KSGER 96W 24V 5A Power Supply Unit For STM32 STC OLED T12 Digital DIY Soldering Station Controller

Soldering Power V2.04

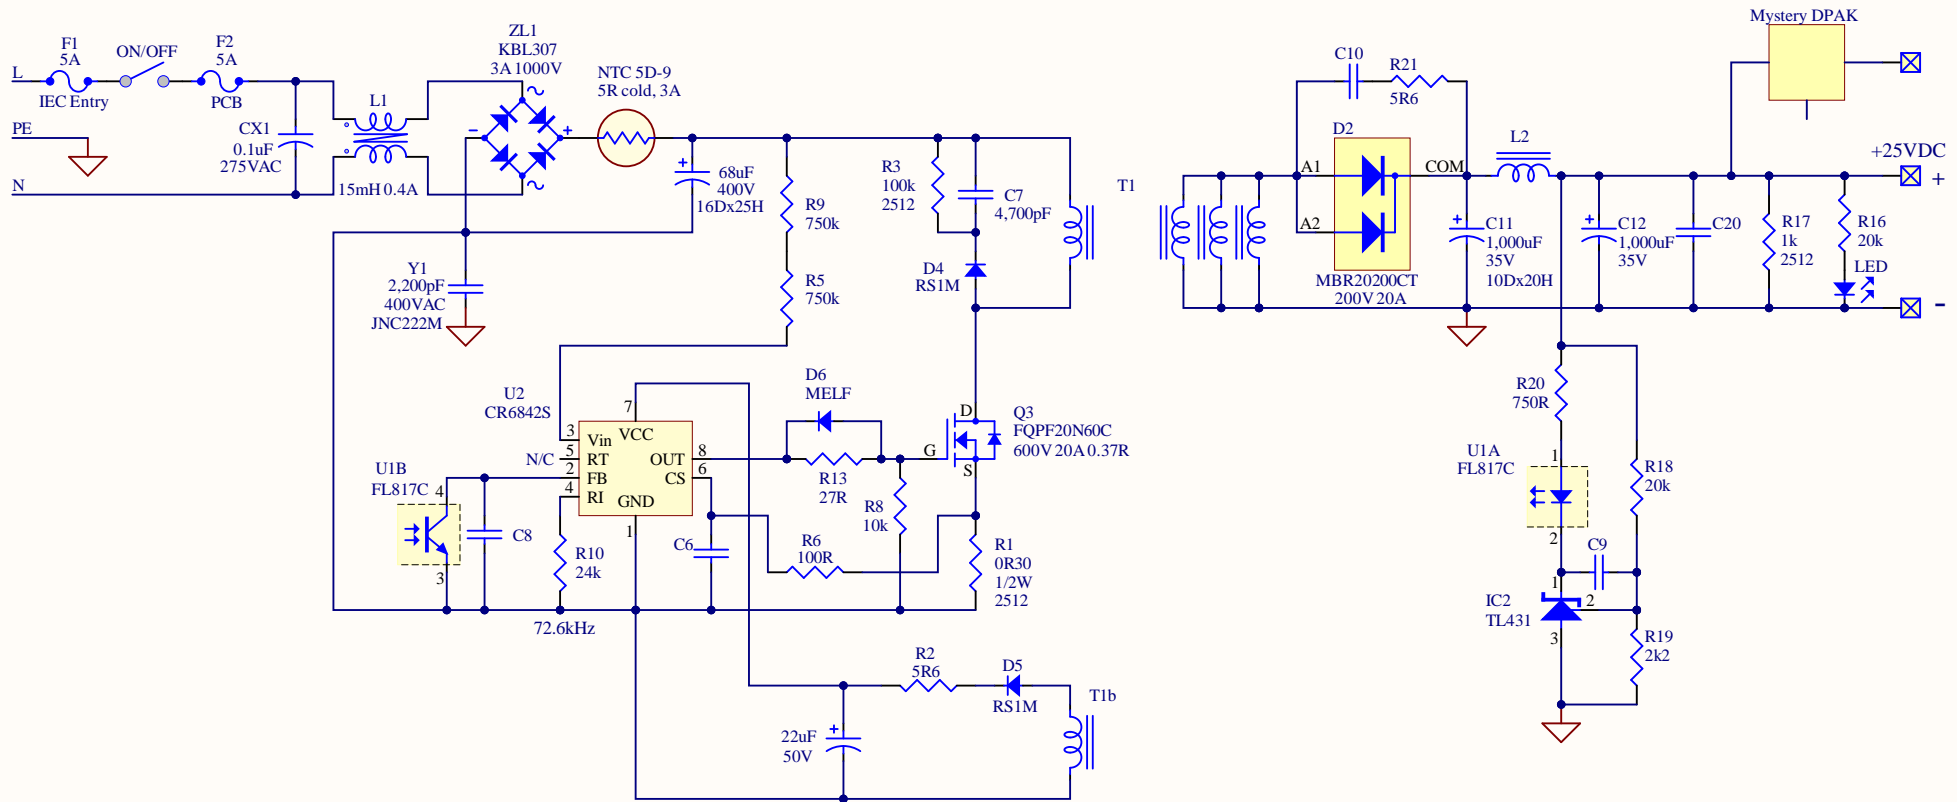
Notes:
Skinny trace for PE GND
+HV trace goes under heatsink :(
No bleeder resistor for primary cap
No chassis GND connection at all
5A fuses are too large
C7 is only 100V polyester
